Proposed Revisions to a Standard Plans Index

Index Number: 102-660

Index Title: Sidewalk Closure

PEDESTRIAN DIVERSION - OPTION 2
(Work Zone Speed 35 mph or Less)

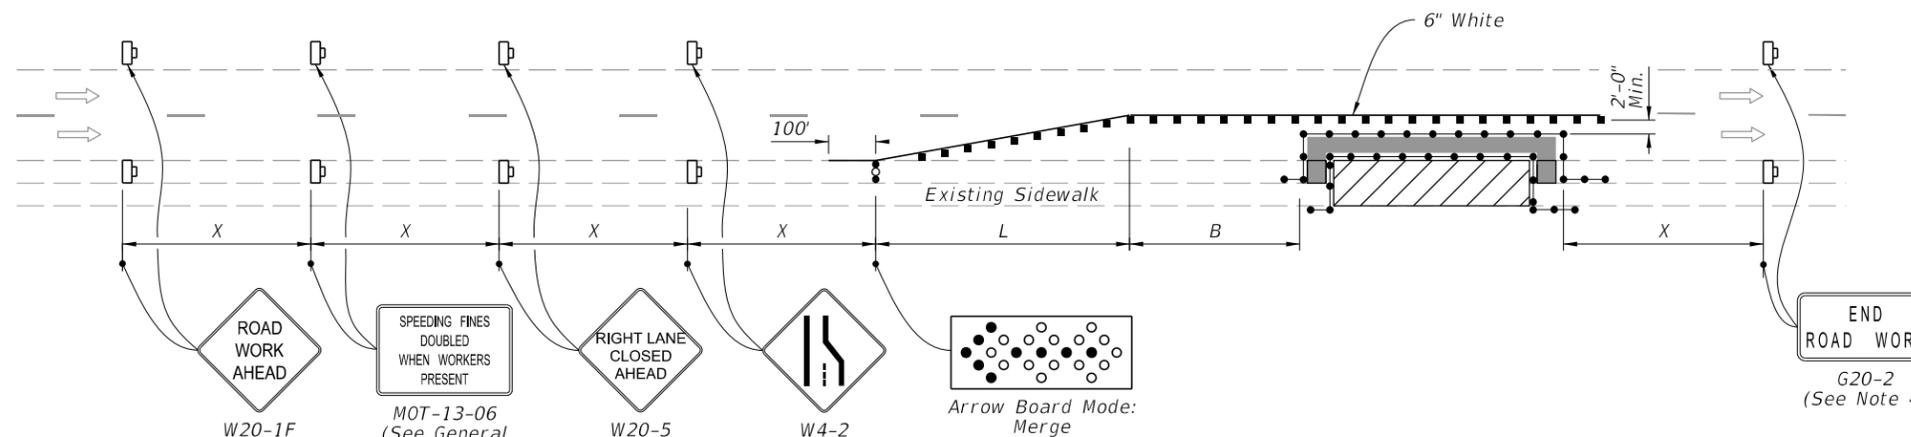
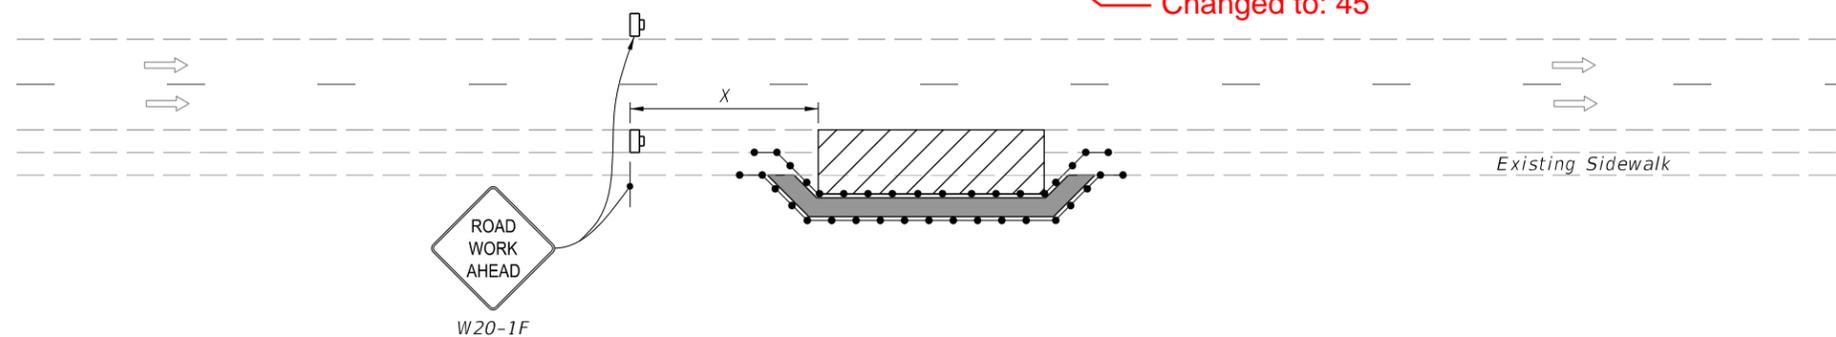
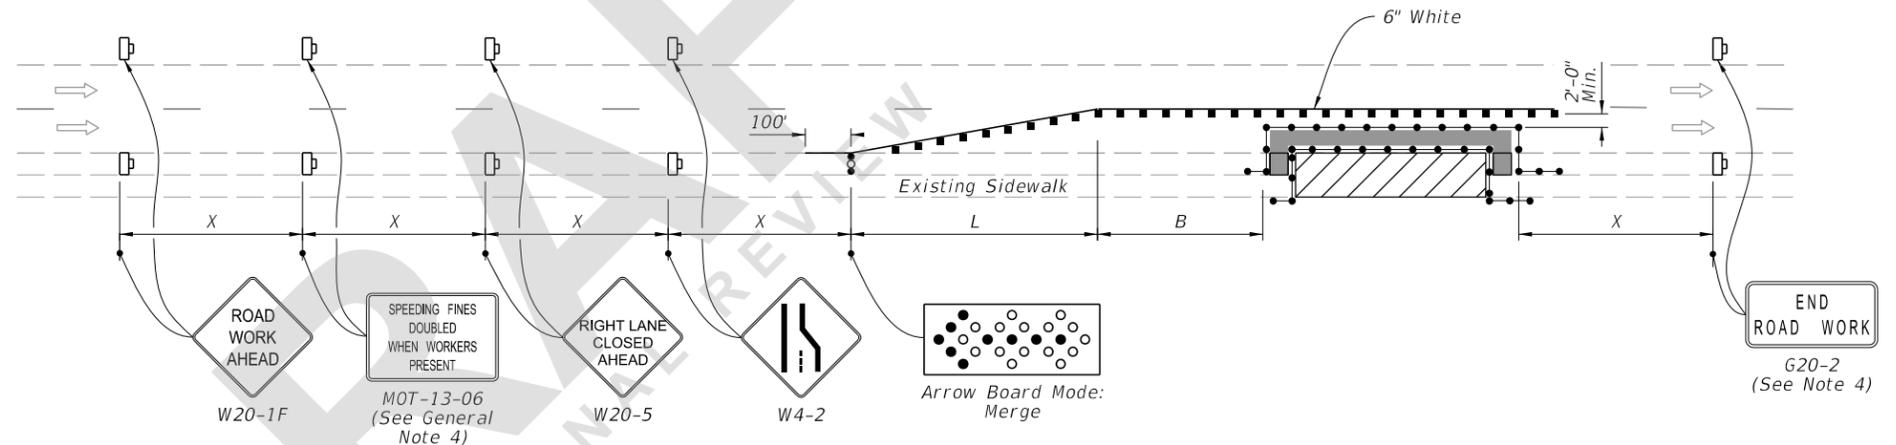
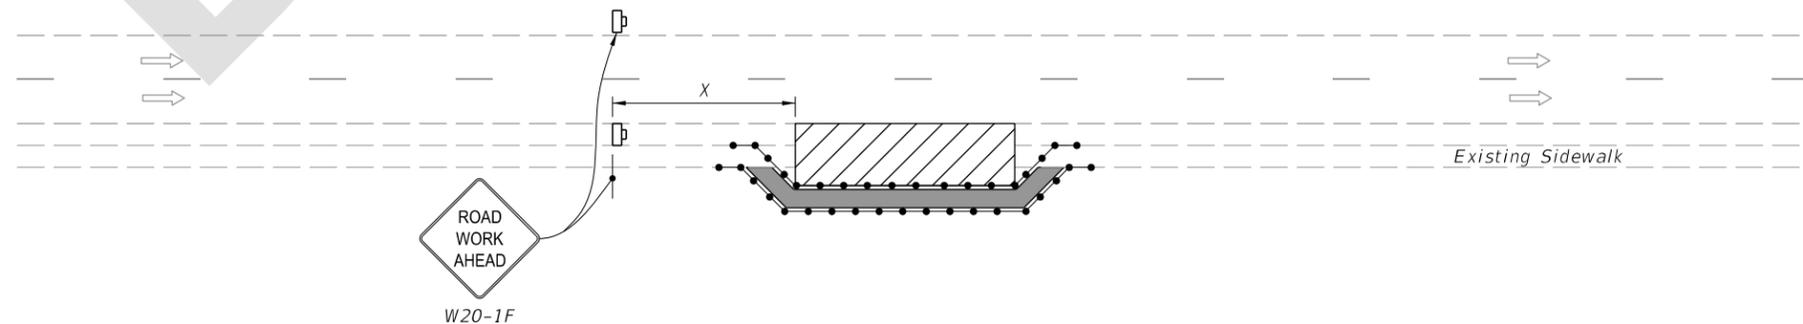
Increase the maximum work zone speed allowed for option 2 to 45mph.

With the work zone speed capped at 35mph, it creates a gap in the applicability of option 2. There have been work zones that needed to use option 2 because they could not meet the length of need requirements for option 1 but the speed limit was greater than 35mph. This makes using a lane closure for pedestrian accommodations difficult in these areas.

Changed to: 45

PEDESTRIAN DIVERSION - OPTION 2
(Work Zone Speed 45 mph or Less)
